WINDOWS - BASEMENT

SCHEDULE 'F'

The Brookside 40' SERIES

From: Victor Da Silva <vdasilva399@gmail.com>
Sent: Friday, March 20, 2020 5:59 PM
To: Yolande Somerville
Subject: Re: PV-137 Pre-structural order

BASEMENT | ELEV. A

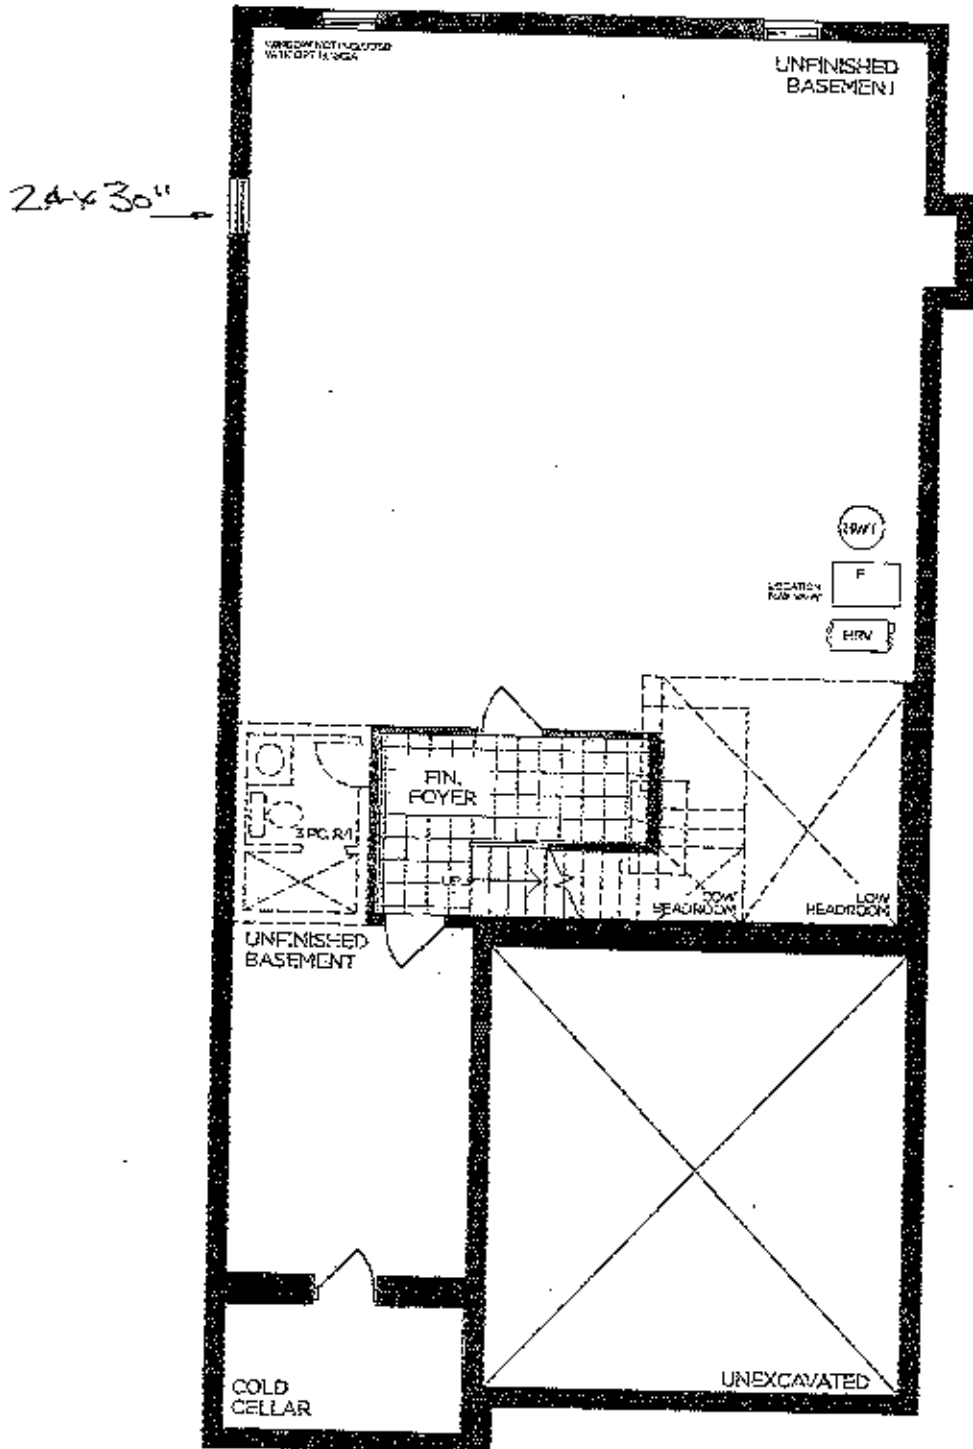
Invoice	Qty.	Description
2231 31691 23Mar20	1	BASEMENT WINDOWS - UPGRADE BASEMENT WINDOW SIZE TO 30 " X 24" - 8" FRAME SIDE ELEVATION - REAR SEE PLAN FOR LOCATION
2231 31691 23Mar20	1	BASEMENT WINDOWS - UPGRADE BASEMENT WINDOW SIZE TO 30 " X 24" - 8" FRAME SIDE ELEVATION - REAR SEE PLAN FOR LOCATION
